Subject: Response to the Second Round of NRC's Request for Additional Information by the Office of Nuclear Reactor Regulation for Topical Report (TR) WCAP-16747-P, "POLCA-T: System Analysis Code with Three-Dimensional Core Model" (TAC No. MD5258) (Proprietary/Non-proprietary)

**"Response to the Second Round of NRC's Request for Additional
Information by the Office of Nuclear Reactor Regulation for Topical
Report (TR) WCAP-16747-P, "POLCA-T: System Analysis Code with
Three-Dimensional Core Model"
(TAC No. MD5258) (Non-Proprietary)**

Figure 3: Core outline showing location of bundle flow measurement

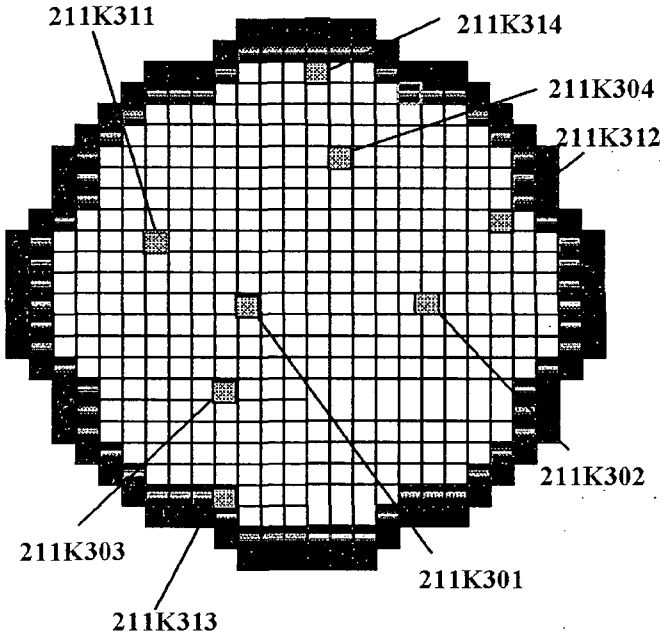
Provide additional descriptive details of the database used to develop the void-quality correlations. Specifically provide as a separate table the nature of any transient tests performed, the range of pressures, mass flow rates, and heat fluxes tested

The bundle flow is measured and compared for the following assemblies shown in Figure 3 below.

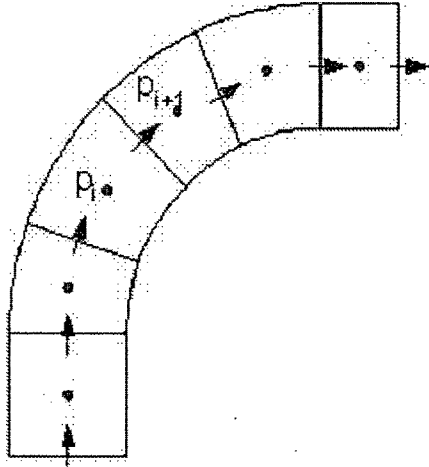
- (b) Describe the models in POLCA-T that calculate the pressure drop across a volume cell representing an elbow in a pipe

The figure below shows a horizontal bend, divided into a number of volume cells. At the flow junction the state vector is the liquid and gas velocities indicated by an arrow and calculated at the surface of the volume cell. In each volume cell the state vector at the dot is the pressure, void, liquid and gas temperatures and average liquid and gas velocities. The liquid and gas velocities are solved by iteration of the momentum equation and the drift flux correlation.

Figure 1: Model representation of pellet relocation.

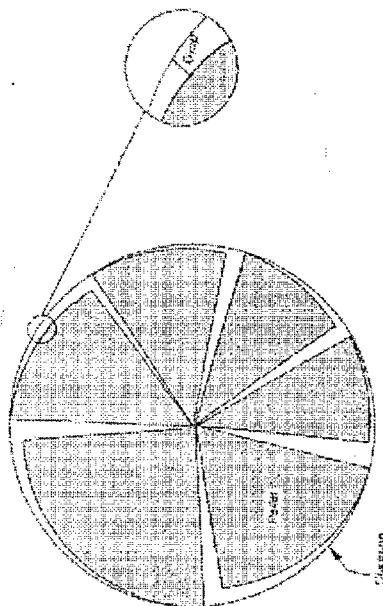
(1) For (U,Gd)O₂, please present relevant fuel cracking data inputs to the code to demonstrate that POLCA-T predicts correct results for this fuel.

controls the mean gap heat transfer, as shown in Figure 1 below.

where κ is the fuel pellet conductivity, a is the pellet radius and $C (=15.0)$ is an empirical constant. The mean heat transfer coefficient of the gap with the fragmented pellet is obtained by employing Eqs. (A-3) and (A-4) in (A-1) and carrying out the integration. The integration is performed numerically with the aid of the Gauss-Laguerre integration method.

Figure 11-4-1, Gd fuel thermal expansion data up to temperature 1233°C (Ref. 1 below)

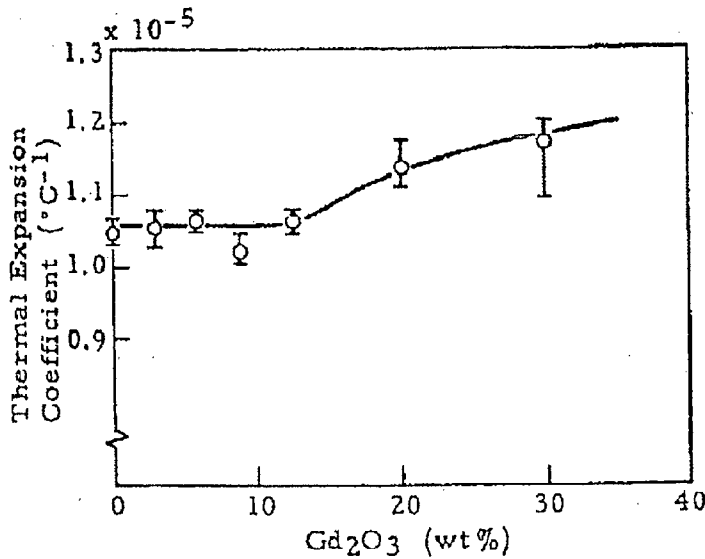
(2) If so, please present the justification including the correct use of the coefficient of thermal expansion at transient temperatures.

POLCA-T code is currently applied to the same level of burnable poison of Gd₂O₃ as in Topical Report WCAP-15836-P-A, []^{a,c} However, regarding thermal expansion behavior, it was shown in Ref. 1 that the thermal expansion coefficient of the UO₂-Gd₂O₃ solid solution could be regarded as []^{a,c} of pure UO₂ in the relatively wide composition range of Gd₂O₃, []^{a,c} see Figure.11-4-1.
